AIA Document G731™ – 2019

Change Order, Construction Manager as Adviser Edition

PROJECT: (name and address) Central Hardin High School Addn/Renov Cecilia, KY	CONTRACT INFORMATION: Contract For: BP 084-02 Alum Frmd Ent & storefronts, Glz C Walls Date: July 14, 2021	CHANGE ORDER INFORMATION: Change Order Number: 087 Date: November 8, 2023
OWNER: (name and address) Hardin County Board of Education 65 W A Jenkins Road Elizabethtown, KY 42701	ARCHITECT: (name and address) JRA Architects 3225 Summit Square Pl, Ste 200 Lexington, KY 40509	CONSTRUCTION MANAGER: (name and address) Alliance Corporation 116 E. College Street Glasgow, KY 42141
CONTRACTOR: (name and address) Lake Cumberland Glass LLC P. O. Box 560 Russell Springs, KY 42642

Proposal Request

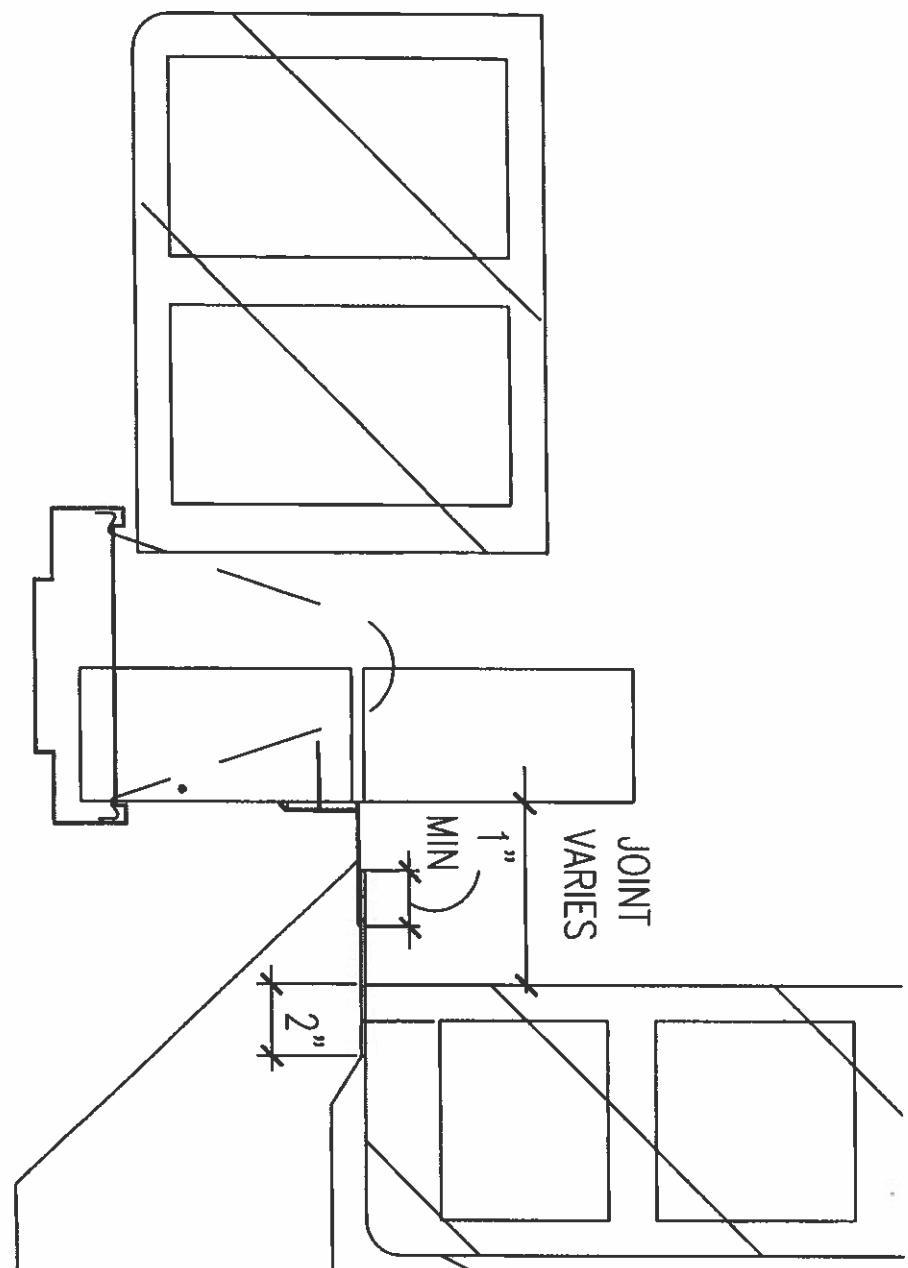
The door and window openings (See PR for added windows and expansion joints) into the gym on the Sub Level Area A must have expansion joints that have fire resistant rating. To achieve this, the fire-resistant joint system must be added to the expansion joints already shown at the heads, jambs and sills of the windows and doors.

ALUM EXP JNT REV

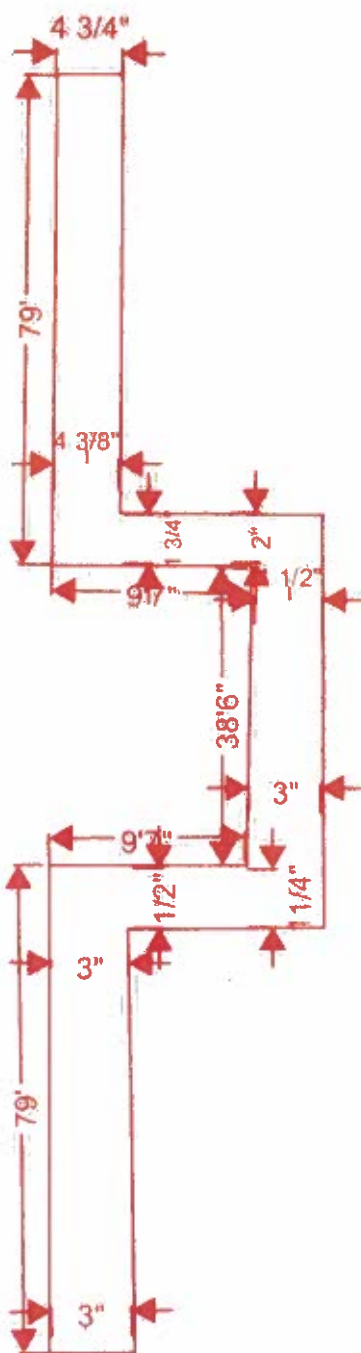
The contractor and supplier need to review the fire-resistant rated joint at the water stop detail on the platform (Detail E-A-312) to ensure that the variations in the width of the joint caused by the irregular conditions between the gym wall and the water stop can be met with the fire resistant rated joint material. Obtain an engineering judgement if necessary.

ENGINEERING JUDGMENT FIRESTOP DETAIL

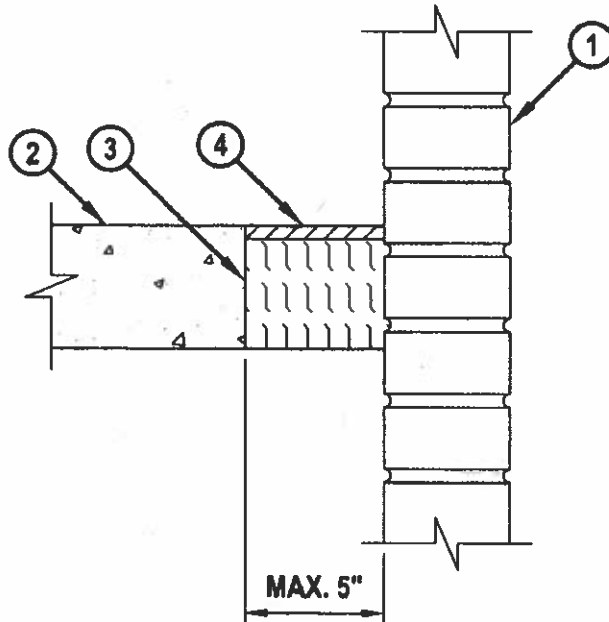
A fire-resistant rated wall to wall joint must be added in the 2" wide expansion joint between Area A and Area B from the First Level up to the water stop detail on the mechanical platform. Since this is concealed in the double wall construction, no expansion joint cover is required.

1. CONCRETE WALL ASSEMBLY TO BE ONE OF THE FOLLOWING (2-HR. FIRE-RATING) :
 - A. LIGHTWEIGHT OR NORMAL WEIGHT CONCRETE WALL (MINIMUM 4-1/2" THICK).
 - B. ANY UL/cUL CLASSIFIED CONCRETE BLOCK WALL (MIN. 4-1/2" THICK) (SOLID OR GROUT FILLED).
 - C. LIGHTWEIGHT OR NORMAL WEIGHT BRICK WALL (MIN. 4-1/2" THICK) (SOLID OR GROUT FILLED).
2. LIGHTWEIGHT OR NORMAL WEIGHT CONCRETE FLOOR (MINIMUM 4-1/2" THICK) (2-HR. FIRE-RATING).
3. MINIMUM 4" THICKNESS MINERAL WOOL SAFING (MIN. 4 PCF DENSITY) COMPRESSED 50%.
4. MINIMUM 1/2" DEPTH HILTI CFS-S SIL GG FIRESTOP SILICONE SEALANT OR HILTI CFS-S SIL SL FIRESTOP SILICONE SEALANT.

NOTES : 1. MAXIMUM WIDTH OF JOINT = 5".
 2. T-RATING MAY NOT EQUAL F-RATING IN ACCORDANCE WITH APPLICABLE TEST METHOD.
